**Re: Moorebank Precinct West Stage 3 (SSD-10431) – Liverpool City Council
Objection**

Re: Moorebank Precinct West Stage 3 – Liverpool City Council Advice on SEAR's

Figure 1 - Proposed Subdivision Plan MPW Stage 3

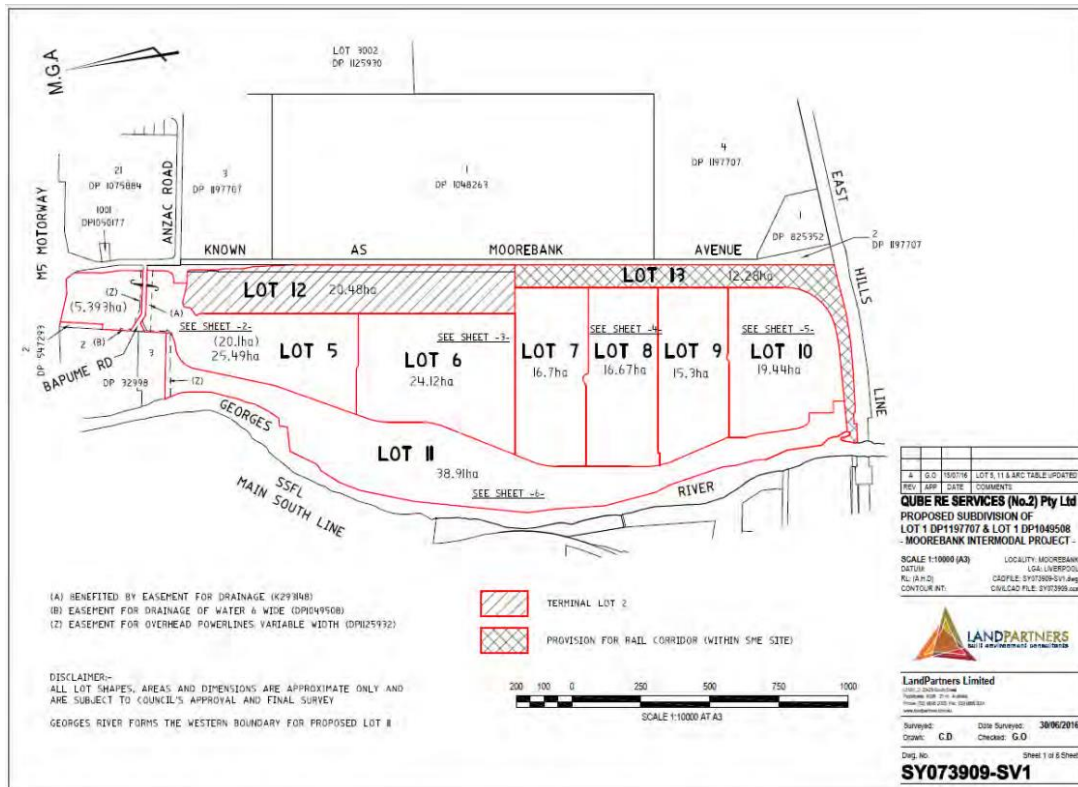
The Liverpool Local Environmental Plan 2008 (LEP) requires a minimum lot size of 120 ha across the MPW site under Clause 4.1 minimum subdivision lot size. It is noted that within the Report, attention is drawn to Section 4.38(3) of the EP&A Act which states the following:

It is acknowledged that a partly prohibited development may be granted consent. The relevance of this clause to this matter is questionable however, given that the Clause 4.1 within the Liverpool LEP is a development standard and not a prohibition.

Nonetheless, the proposed subdivision will result in a contravention of a development standard in the order of 11,987.72%, or a 107.72ha shortfall in lot size. This is an enormous variation to the existing development standard, and Council does not see this as a partial non-compliance.

Given the points and concerns outlined, Council is not supportive of the proposed subdivision included within the Moorebank Precinct West Stage 3 application. If such a lot configuration is to be pursued, this would ordinarily be considered through a planning proposal to ensure such a variation to a development standard has site and strategic merit. This planning proposal should include an Economic Impact Statement that identifies the potential ramification such a proposal would have on surrounding industrial land within Liverpool.

Council requests that a concurrent planning proposal be lodged to ensure an appropriate assessment of the potential impacts is undertaken with regard to the proposed subdivision of the MPW development site.
